**TOWN OF BOXFORD**

**HVAC, Exterior Repairs, Library Renovation  
Town Hall/Library  
7A Spofford Road  
Boxford, MA**

ADDENDUM NO. 4  
AUGUST 25, 2020

**SKA-3**  
Addendum #4

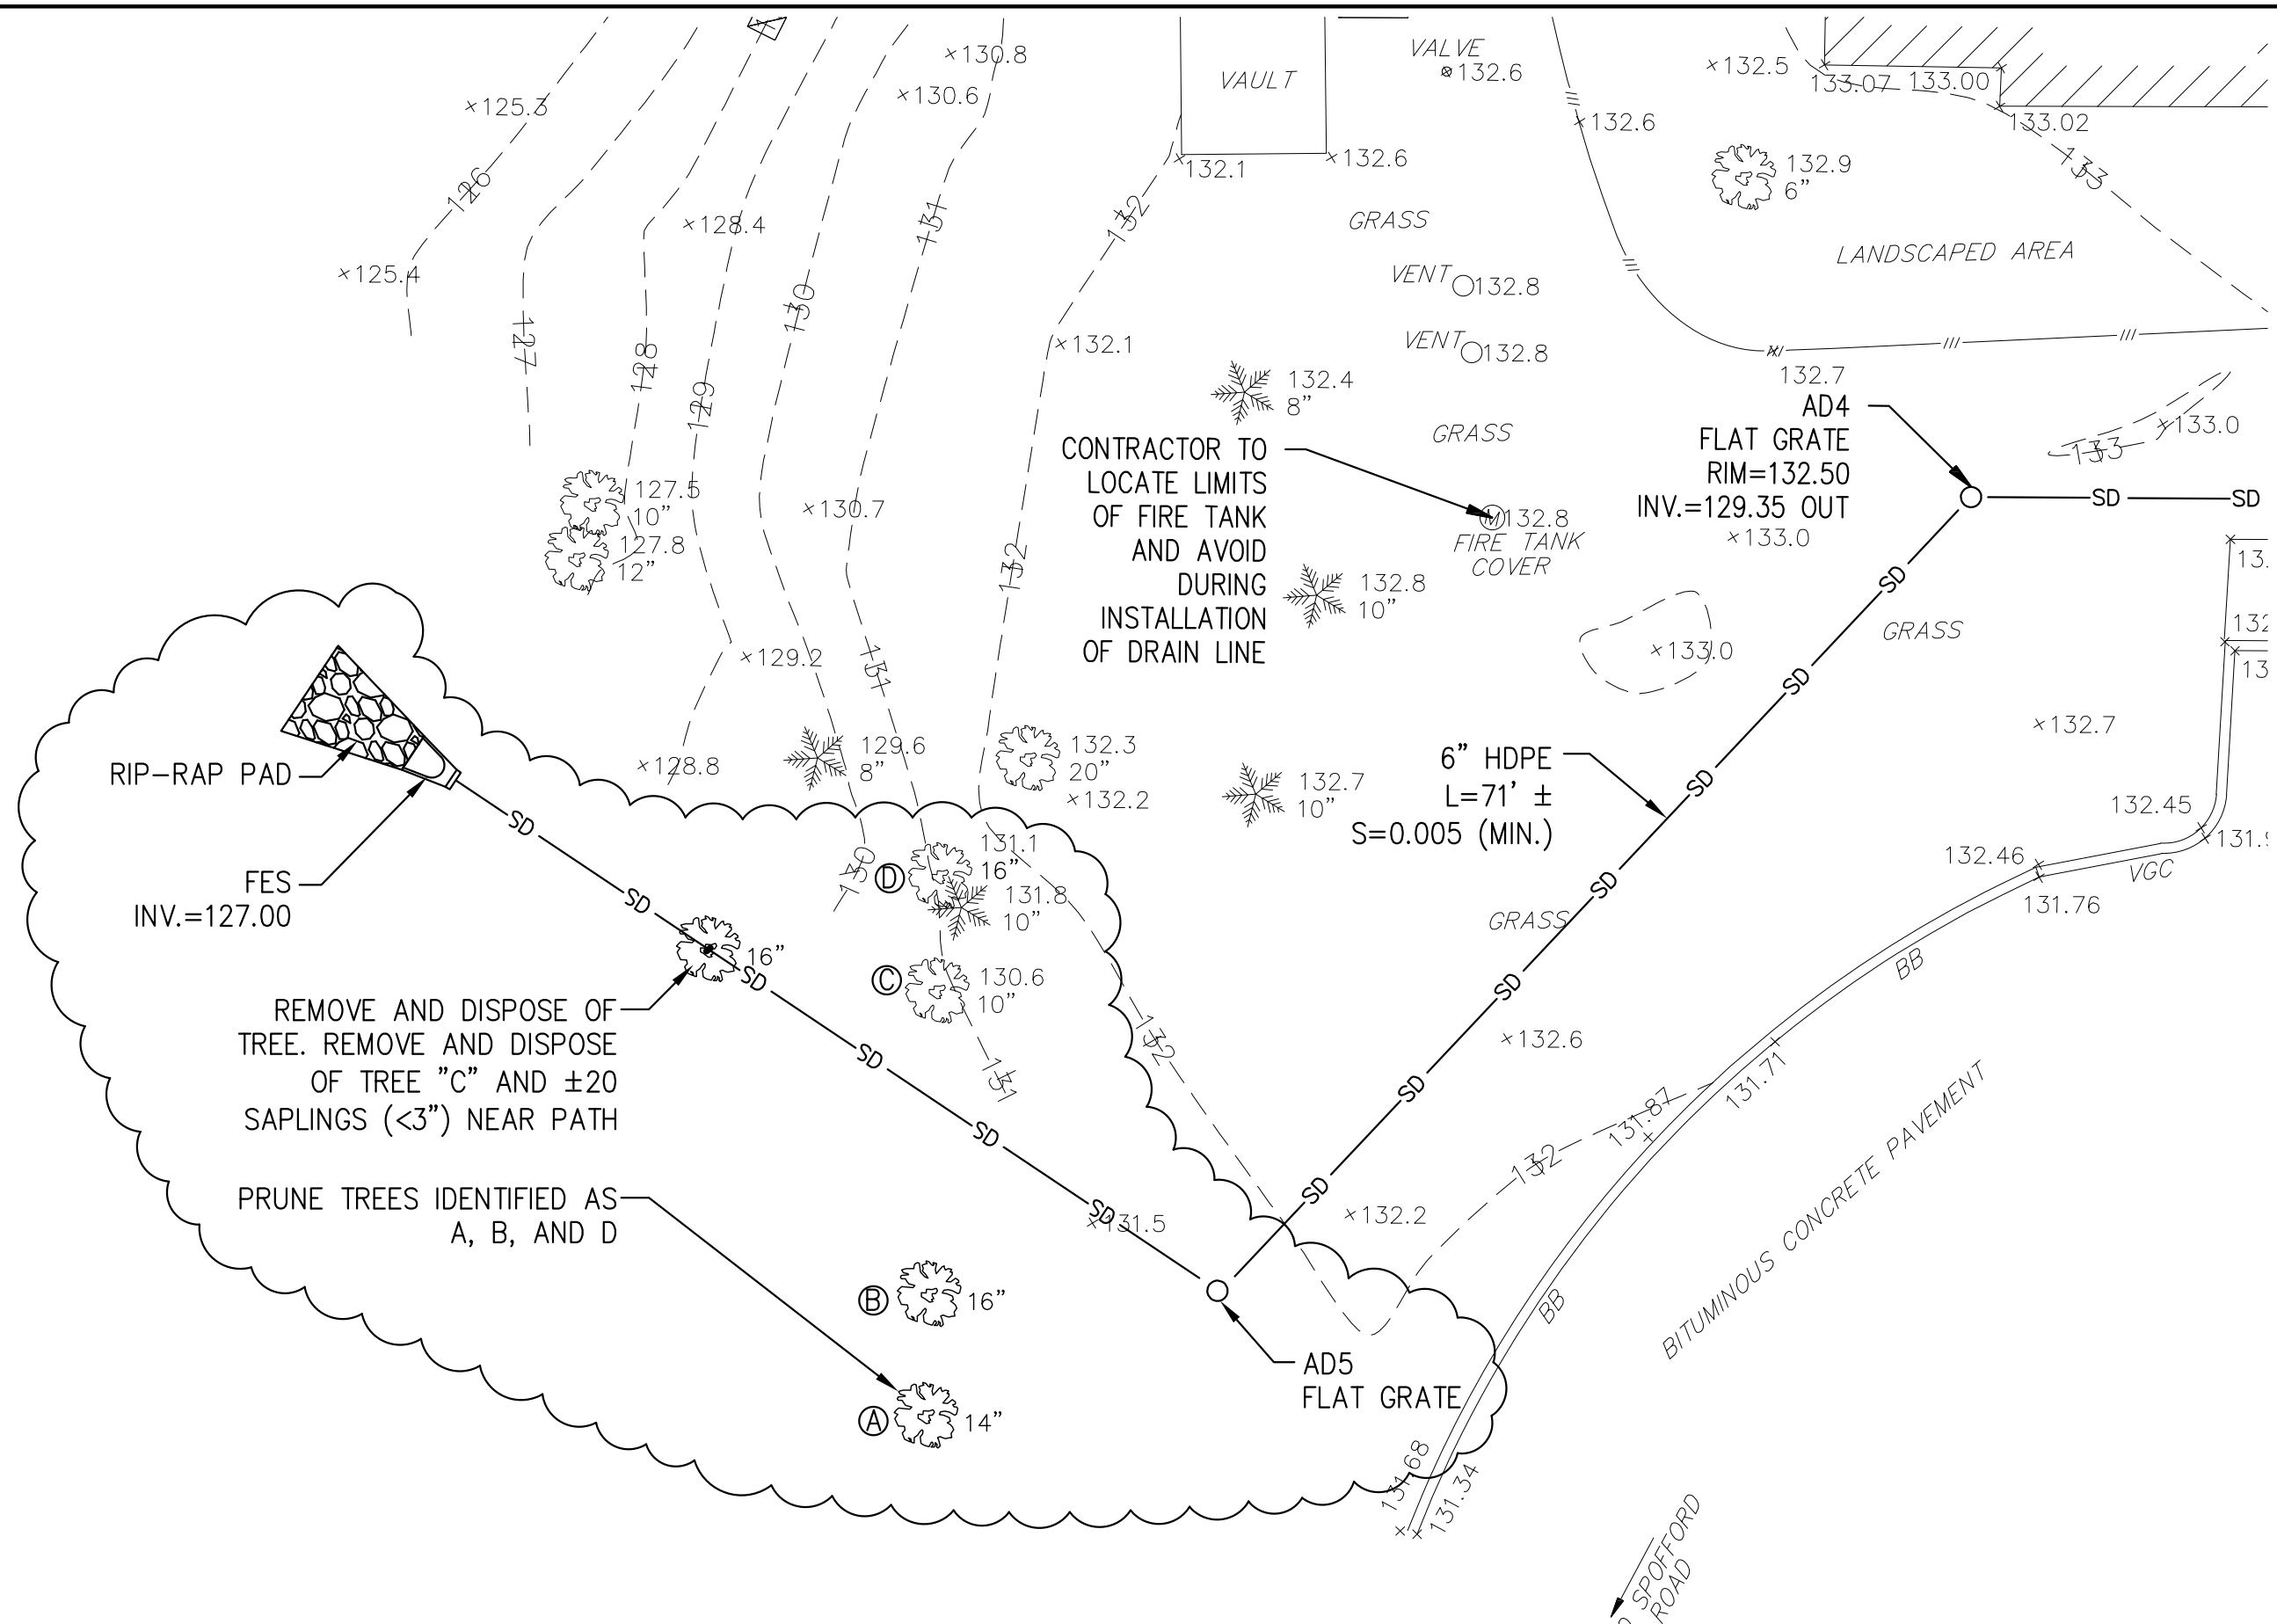
1. **Drawing C101 SITE PLAN OF LAND IN BOXFORD, MA**

1.1. ADD and REPLACE notes and drawing information as indicated on the attached SKA-3.
